DEPARTMENT OF PLANNING AND DEVELOPMENT  
CITY OF CHICAGO

**Re: Administrative Relief request for Planned Development No. 1370, Sub area A  
Proposed residential tower at 1600 E. 53<sup>rd</sup> Street**

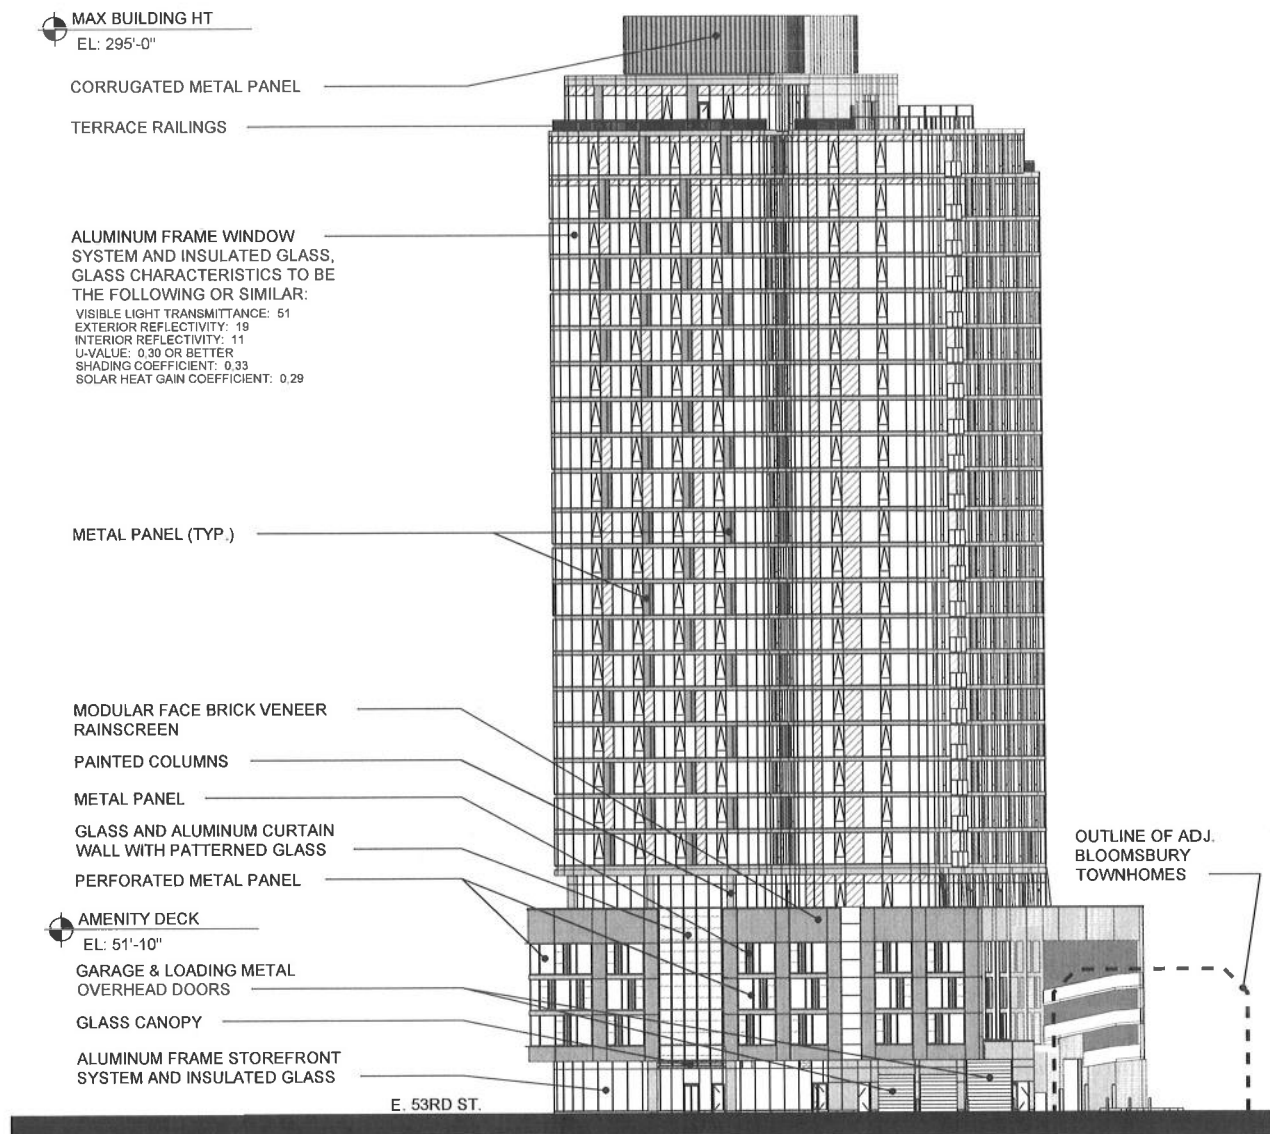
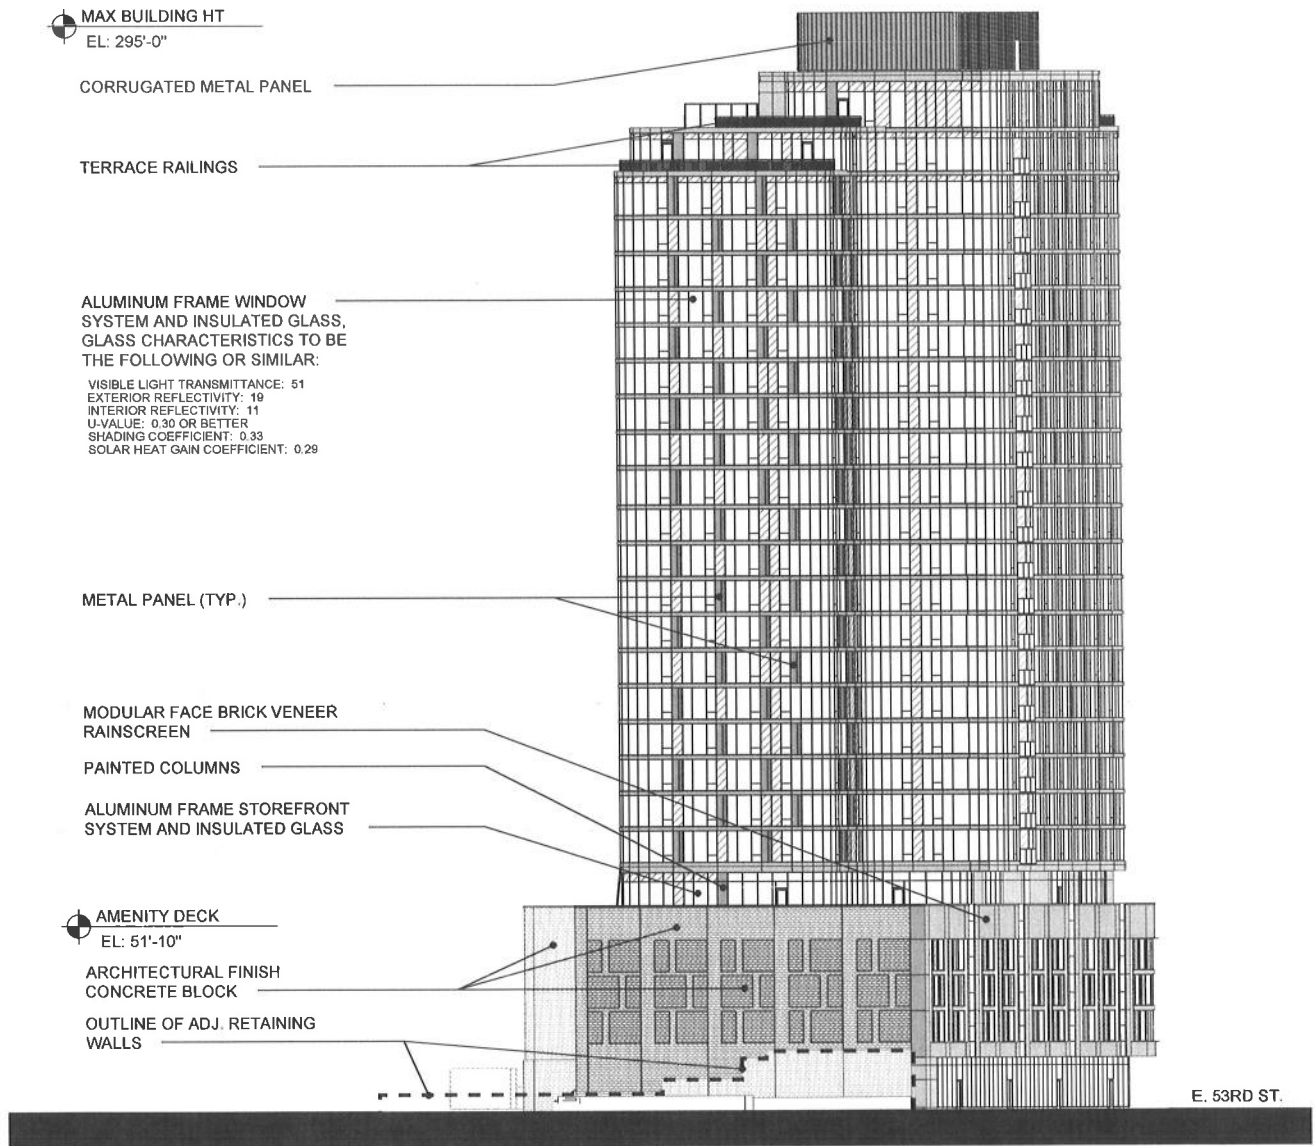
- Modifications to the building's podium, including the replacement of fiber cement panels with modular brick. Each of the podium bays has been modified and vertical fins, similar to those in the tower redesign have been added. Along 53<sup>rd</sup> St., the retail space has been recessed several feet and an overhanging soffit has been added. Along Cornell Ave., the glass 'waterfall' feature has been redesigned. The podium's three parking levels have been reshaped to a prow that corresponds to the angle of the streets, and within the parking levels, the concrete knee-wall has been replaced with spandrel glass and metal panels.

- Modifications to the tower design, including the substitution of the approved shading devices with vertical fin projections on all four facades of the tower, the elimination of some balconies and the addition of an indoor/outdoor 26<sup>th</sup> floor terrace space.
